REMINGTON ROAD

FACADE CHANGES PROPOSAL REPORT

DELTA ARCHITECTS

REVISION: P7

SECTION 1. VERTICAL 10mm RECESSED STACK BOND RED BRICK

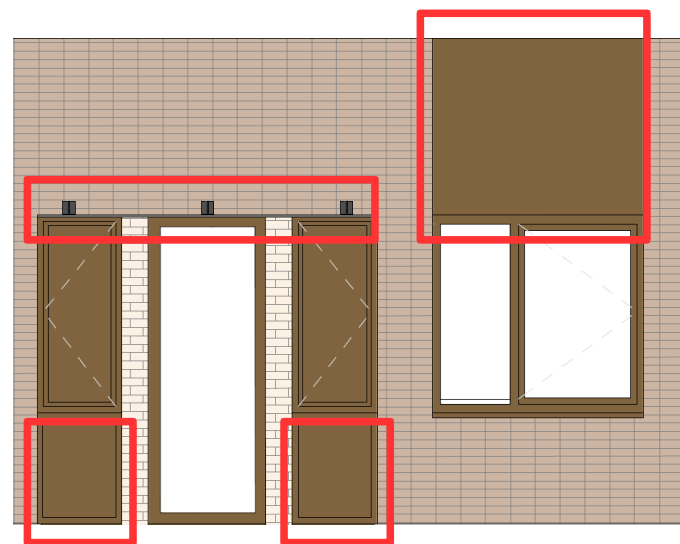
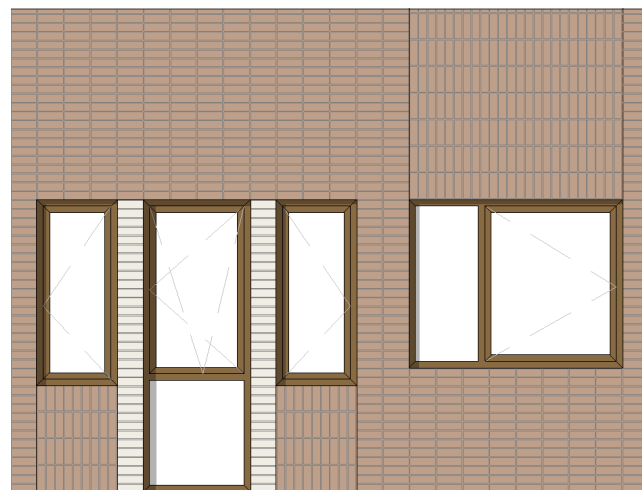
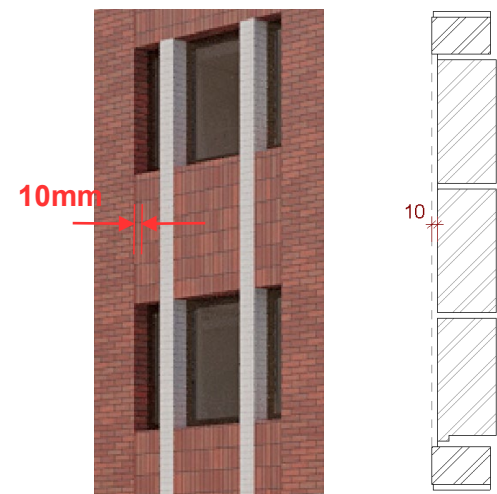
PPC Aluminium panels (RAL 1036) are currently proposed for underneath and above the windows.

- In the context of the Remington road project, there is limited local precedence for the local vernacular based upon the current approval of aluminium PPC panels. The longevity of PPC coatings can vary, with the potential for chipping and fading over time. Moreover, water ingress. Movement joint issues, mastic failures and connections at windows can pose additional concerns.

The PPC panels underneath and above the windows are proposed to be replaced with vertically stacked red brick recessed into the façade by 10mm.

- Red Brick (Wienerberger brick Grove Orange) is the proposed predominant façade material. The red brick is the most appropriate for the site, considering the existing vernacular is to a large extent red brick. The red brick is used for the apartment blocks A, B, C, Maisonettes and Townhouses, giving cohesion to the development.
- The red and white bricks are proposed in keeping with the existing buildings in the local area. The recessed red brickwork will create a visually interesting façade with varying depths and textures.

SECTION 2. HORIZONTAL RUNNING BOND BRICK PIERS BETWEEN WINDOWS

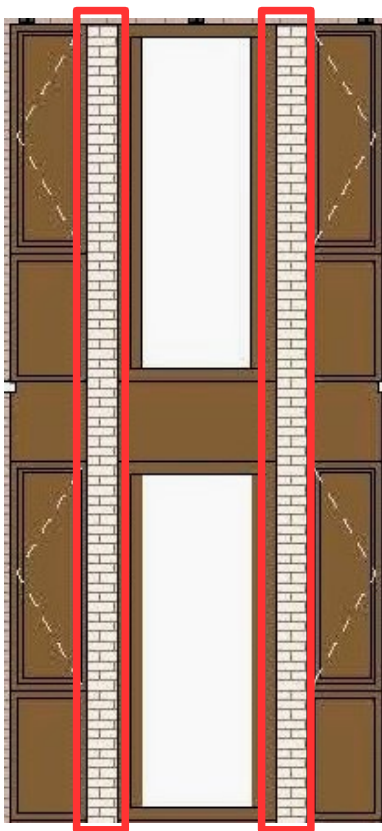
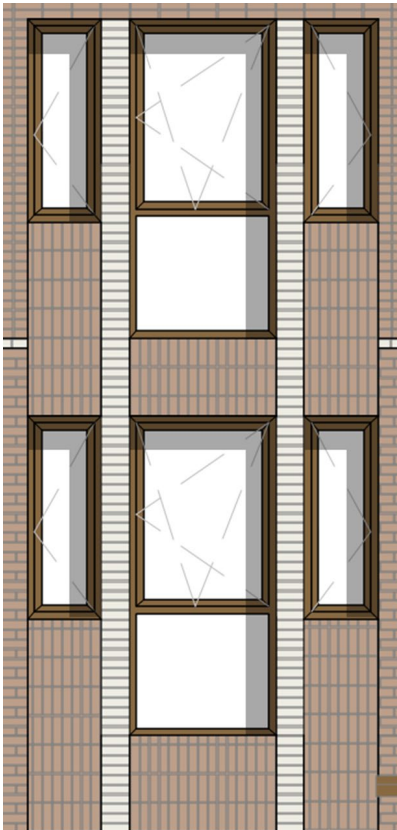
Stretcher bond white bricks are currently approved for between windows.

White stacked bricks are proposed to replace the stretcher bond to create a more cohesive connection to the rest of the brick patterning throughout the development.

- The pier will remain at 215mm which is the same size as a brick module, this will reduce the amount of brick cutting and residual waste on the site

SECTION 3. BANDING (ONE BRICK COURSE)

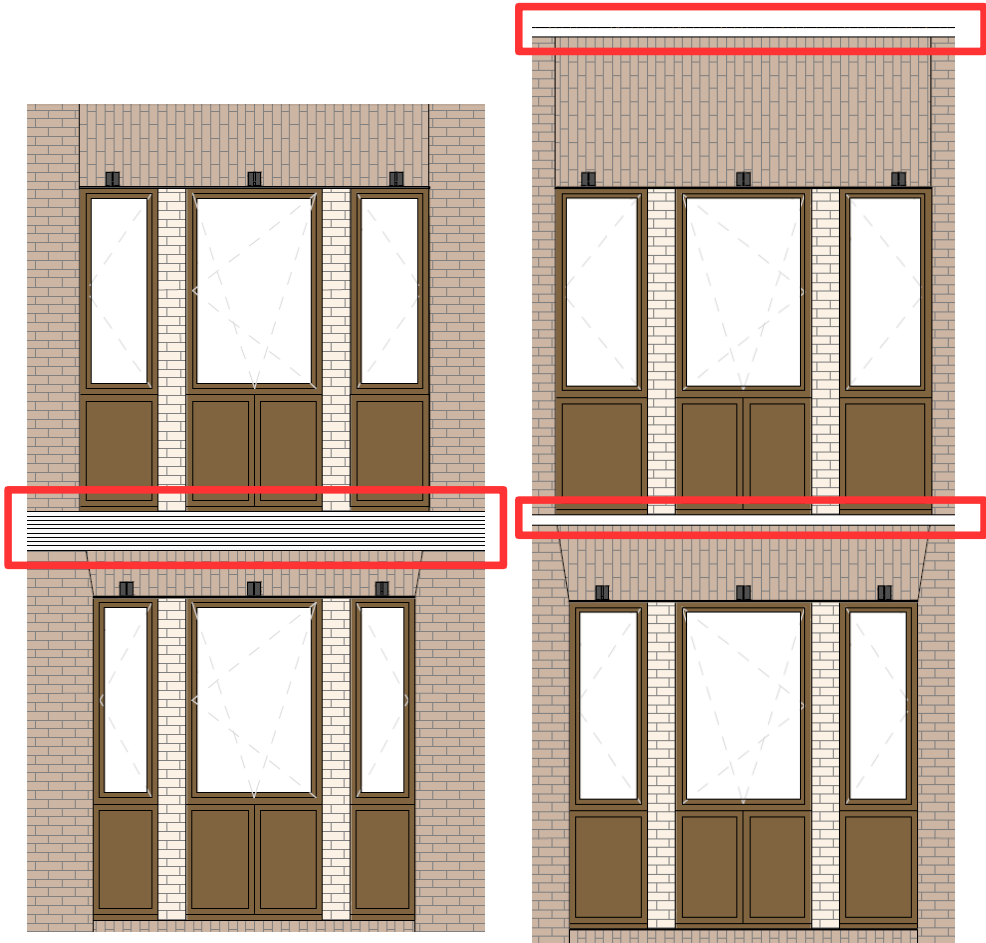
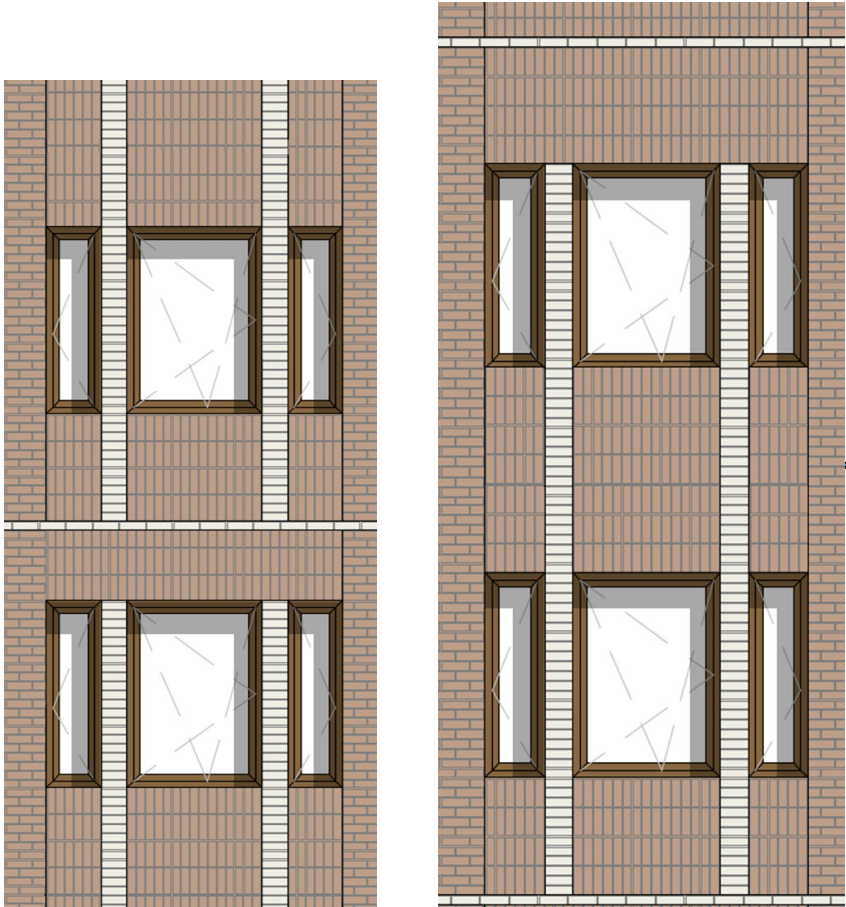
White Portland cast stone is currently approved in varying forms and patterning. This occurs at 2nd, 4th and 5th slab levels.

The proposed banding would be replaced with a white brick banding to create a more connected façade with the vertical piers. The FFL of the 1st, 3rd and 5th floors are proposed to be treated with a brick banding that creates a visual break from one floor to the next. The top level of the townhouses and maisonettes utilise a white brick banding that is to be flush with the horizontal stretcher (Wienerberger brick Grove Orange).

- The objective of the proposed modification is to enhance the overall visual coherence and consistency of the façade across the site. This proposal aims to rationalise the diverse sizes of the previously approved elements and reduce the pronounced contrast within the material palette.

SECTION 4. BALCONY BALUSTRADE

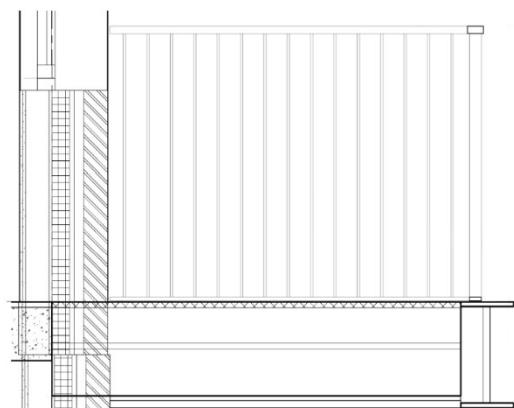
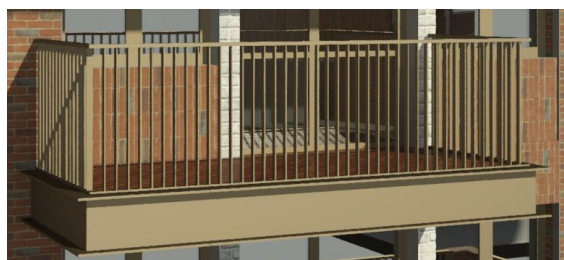
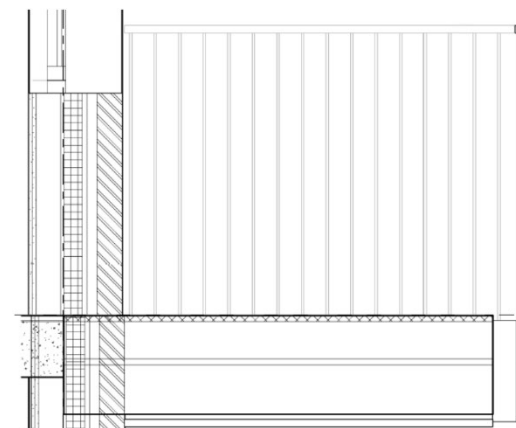
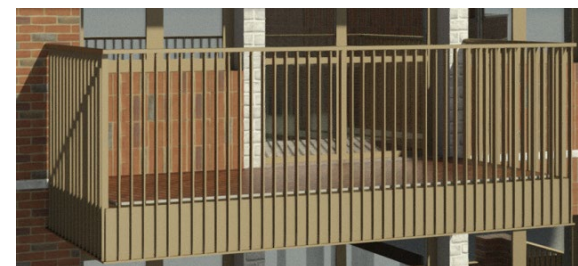
The current approved proposal outlines the typical balustrades with deep angled rails in a W configuration. The balustrades material match the rest of the site with PPC aluminium (RAL 1036). The balustrades are top fixed to the balcony's cantilevered structure.

The proposed balcony balustrades for Block A, B, C would be changed to the fascia fixed system and regularised straight aluminium railing (RAL 1036).

- The more open railings allow light to penetrate into the recessed balcony areas and provide a visual continuity for the cantilevered systems.
- For the cantilevered systems, the proposed fascia fixed balustrades offer a sleek and minimalist appearance with a clean uninterrupted line from top post to soffit mirroring the verticality of the adjacent brick piers.
- The proposed fascia fixed system provides less areas for dirt or moisture to sit without requiring extended cleaning from the tenants.
- The proposed fascia fixed railing maximises the usable space on the balcony by moving the fixings to the perimeter of the balcony.

SECTION 5. PIERS FACADE

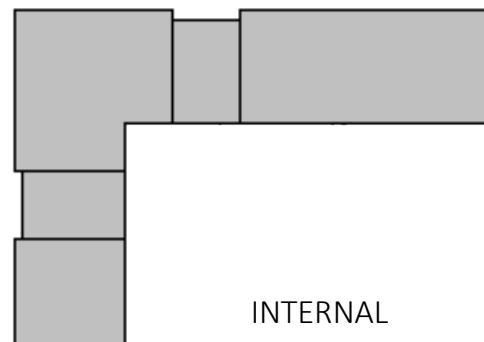
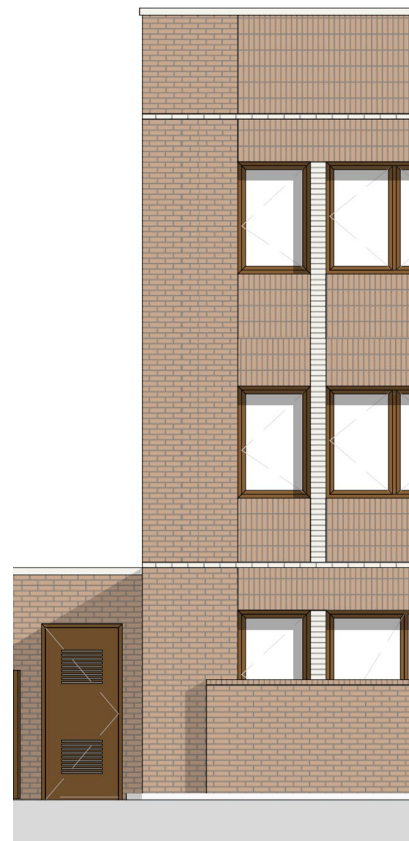
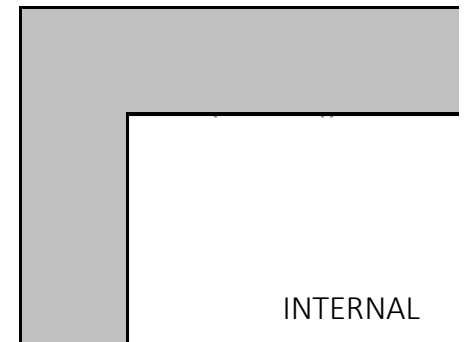
The current approved proposal recessed the brickwork 25mm into the cavity of the external wall. This reduced the residual cavity to 45mm, this brings it under the recommended 50mm to maintain a ventilated partial fill wall system.

The proposal is to remove the recessed brick piers to have a continuous cavity and improved brick support strategy.

- A minimum 50mm cavity has to be provided to the rear of the brickwork to allow for ventilation of the façade against the build-up of moisture. The approved proposal will increase the risk of damp and moisture within the facade. The proposal will increase the cavity to a minimum of 50mm to improve the longevity of the development.

SECTION 6. RAISED PLANTERS AT GROUND LEVEL

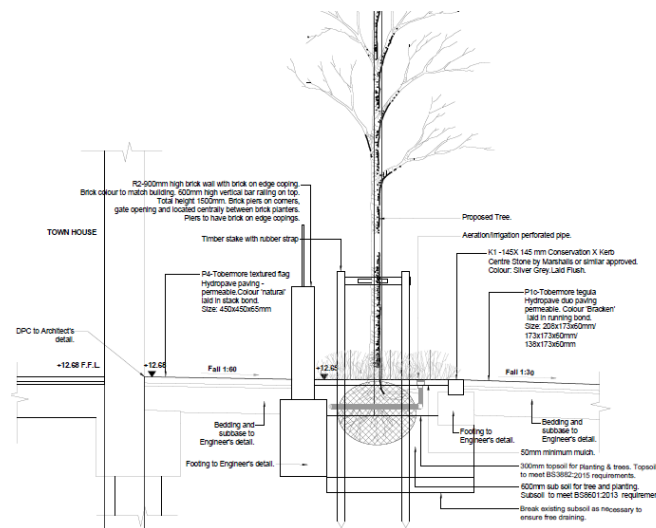
The current proposal utilises raised planter beds outside of the main demise. Within this context and proximity to the demises, raised planters can have a few negative aspects. They can accumulate litter, especially in areas of high foot traffic. Raised beds require a drainage channel away from the box itself. If this is not regularly maintained it can lead to waterlogging. Due to the adjacent patio, the height of the bed can allow for climbing and stepping into the unit's amenity spaces.

The proposal is to replace the raised planters with ground level planters 150mm high.

- A ground level planter creates a better connection to the surrounding areas, without interrupting the view of the ground ahead from eye level.
- The plants can cope more naturally with longer periods without rain or irrigation.
- At the east end of the site, Thames Water asset is located between the two blocks of town houses. A significant number of planters need to be omitted to accommodate the requirements of this asset, i.e. no foundations within its easement.

SECTION 8. STONE COPING TO FRONT PATIO WALLS

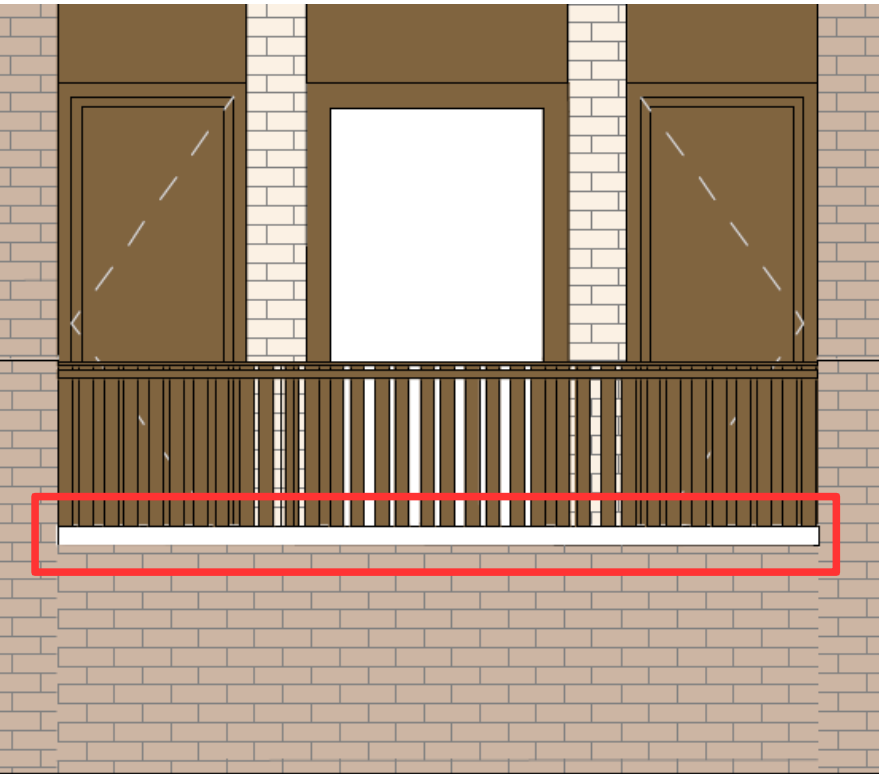
White Portland stone is currently approved for the coping on patio walls.

The proposal is to replace the white Portland stone coping to front patio walls with grove orange brick soldier course to fit more cohesively into the context.

- Red Brick (Wienerberger brick Grove Orange) is the proposed predominant façade material.
- The proposed soldier bricks mirror the stack bricks around the windows, creating an extended frame for the apertures.

SECTION 9. CURTAIN WALLS TO CORE

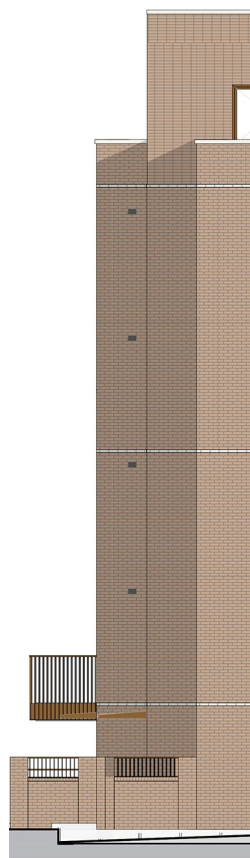
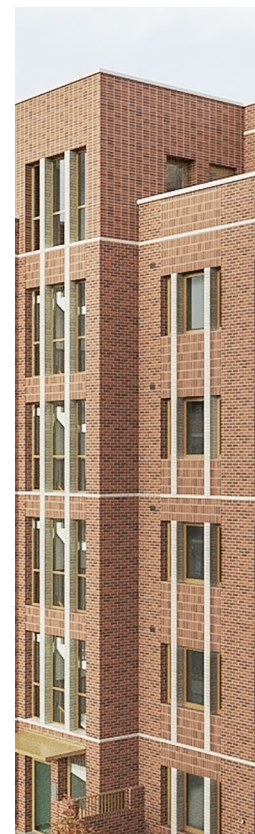
Curtain walls are currently proposed to core A east side.

The proposal is to remove the curtain walls to core as recommended by the fire consultant.

- The proposed brick would Improve fire safety and reduce the risk of external fire spread to neighbouring flats.
- Curtain walling systems are more challenging to maintain and repair in areas requiring high levels of fire protection. Access to the exterior face of the curtain wall for routine maintenance or repairs may be limited due to the location of the stair core.
- The proposal prevents overlooking onto private units from the communal core.

SECTION 10. ENTRANCE CANOPIES

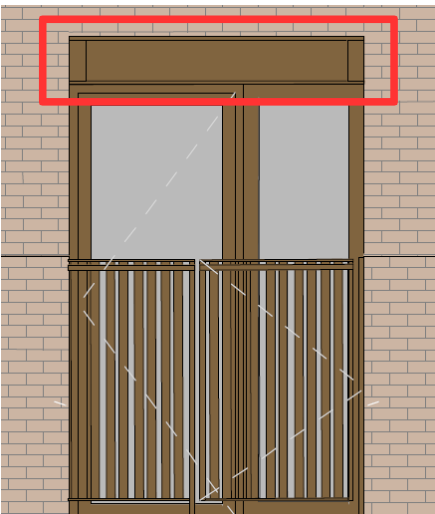
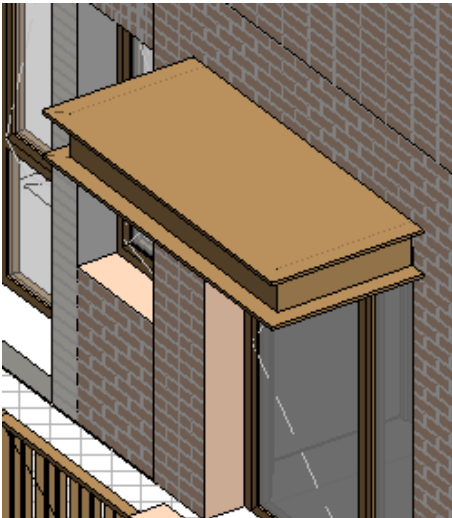
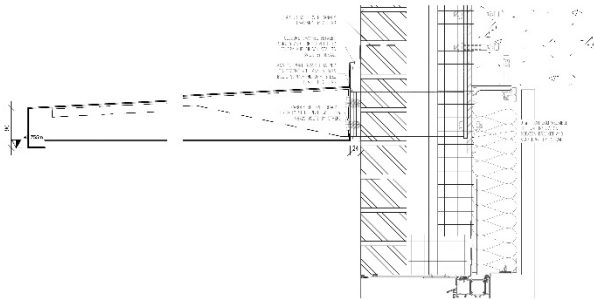
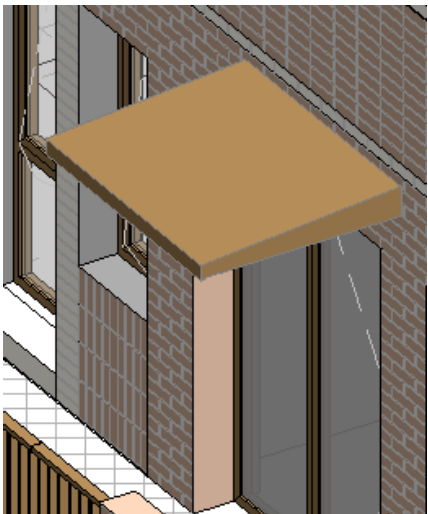
PPC coloured aluminium canopy is the current approved proposal for the apartment blocks A,B,C communal entrances and the ground floor flats, townhouses and maisonettes private entrances.

PPC Aluminium composite canopies (RAL 1036) are proposed to replace the canopies for the communal and the private entrances through changes to thickness and a more streamlined design.

- The thinner canopies will reduce wind load and structural load on the supports, and simplify the fixings required for the units.
- By reducing the size of the canopies, more natural light can reach the entrance area. This will create a brighter and more welcoming ambiance, while also improving safety.
- A smaller canopy will be easier to maintain compared to a larger shaped one. Cleaning and maintenance tasks, such as removing debris or performing repairs, can be more manageable and less time consuming improving continuous access to the buildings.
